### GC0127/GC0128 WORKGROUP ALTERNATIVE 3

Please note all red text indicates new additions/amendments as part of the legal text to facilitate WAGCM3 (which is a combination of WAGCM1 and WAGCM2). This WAGCM includes the amendments below plus the Original Proposal legal text.

Figure 4a – Required capability of an **Electricity Storage Module** when operating in a mode analogous to **Demand** subject to a **Frequency** deviation of below 49.5Hz.

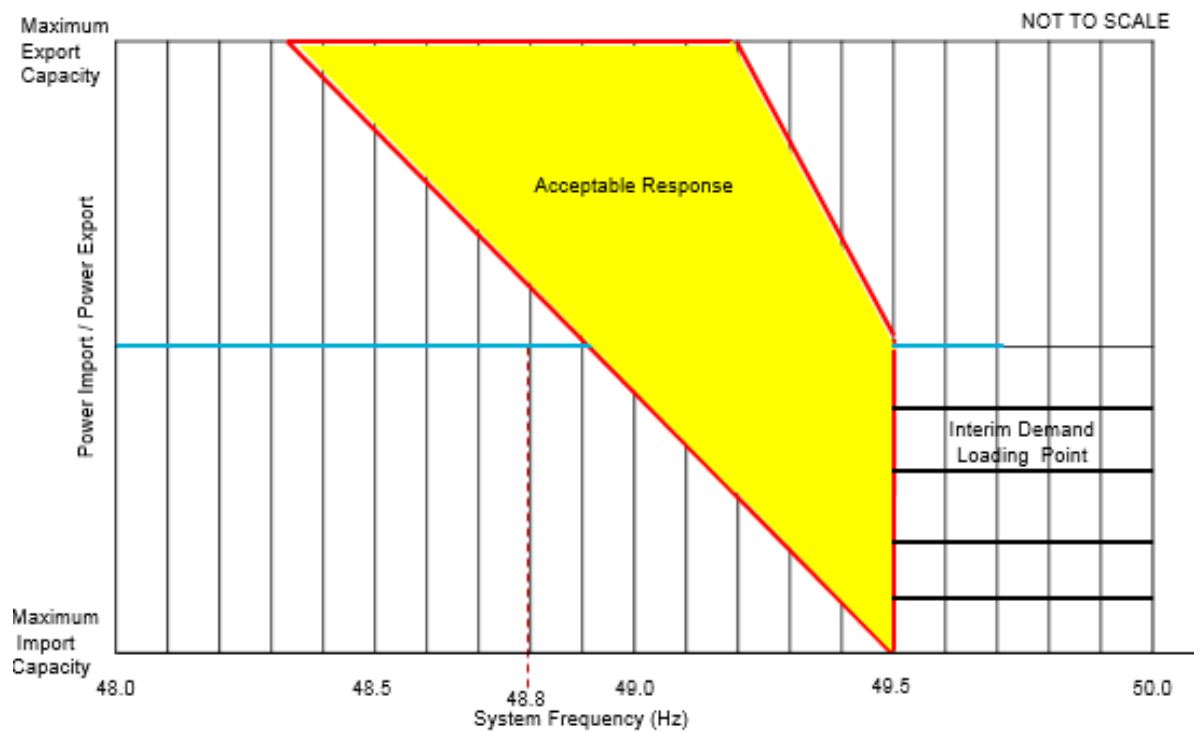
- (ii) In the event that the **System Frequency** falls below 49.5Hz, each **Electricity Storage Module**, which is operating in a mode analogous to **Demand**, and which is also capable of reversing operation from an **Interim Demand Loading Point** (including its **Maximum Capacity** (Pmax Import)) to an exporting mode of operation shall be capable of reversing its mode of operation within 20 seconds. The transition from import mode of operation to export mode of operation shall commence linearly and proportionally as soon as practicable and at the very least within at least 500ms from when the **System Frequency** falls below 49.5Hz. During this transition period, the **Electricity Storage Module** is required to remain stable over the entire operating range of the **Electricity Storage Module**.

- (iii) Each **Electricity Storage Module** which is capable of meeting the requirements of CC.6.3.7(g), shall also be capable of achieving a frequency response characteristic within the shaded area shown in Figure 4a

Figure ECC.6.3.7.2.2.2 – Required capability of an **Electricity Storage Module** and/or energy storage unit belonging to a **GB Emergency and Restoration Code Provider** when operating in a mode analogous to **Demand** subject to a **Frequency** deviation of below 49.5Hz.

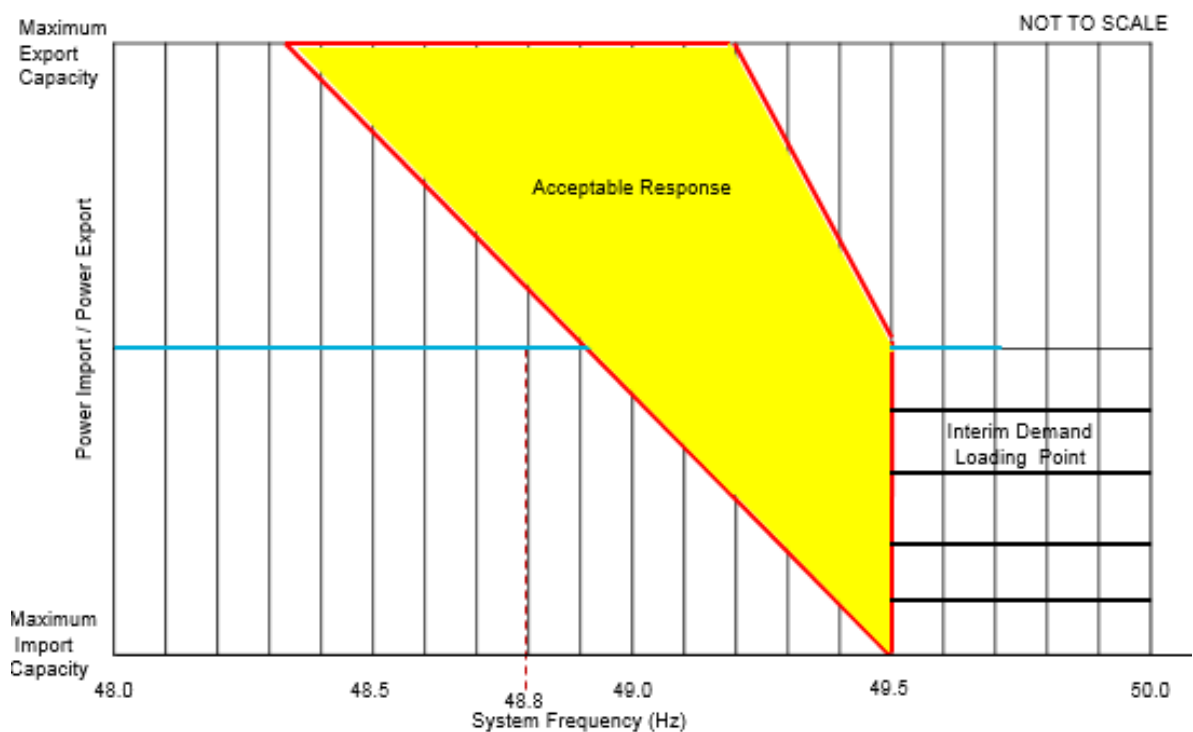
ECC.6.3.7.2.2.2 In the event that the **System Frequency** falls below 49.5Hz, each **Electricity Storage Module** and energy storage unit (belonging to a **GB Emergency and Restoration Code Provider**), which is operating in a mode analogous to **Demand** and which is also capable of reversing operation from an **Interim Demand Loading Point** (including its **Maximum Capacity** (Pmax Import)) to an exporting mode of operation shall be capable of reversing its mode of operation within 20 seconds. The transition from import mode of operation to export mode of operation shall commence linearly and proportionally as soon as practicable and at the very least within at least within 500ms from when the **System Frequency** falls below 49.5Hz. During this transition period, the **Electricity Storage Module** or energy storage unit (belonging to a **GB Emergency and Restoration Code Provider**) is required to remain stable over the entire operating range of the **Electricity Storage Module** or energy storage unit.

ECC.6.3.7.2.2.3 Each **Electricity Storage Module** and/or energy storage unit belonging to a **GB Emergency and Restoration Code Provider** which is capable of meeting the requirements of ECC.6.3.7.2.2, shall also be capable of achieving a frequency response characteristic within the shaded area shown in Figure ECC.6.3.7.2.2.2.
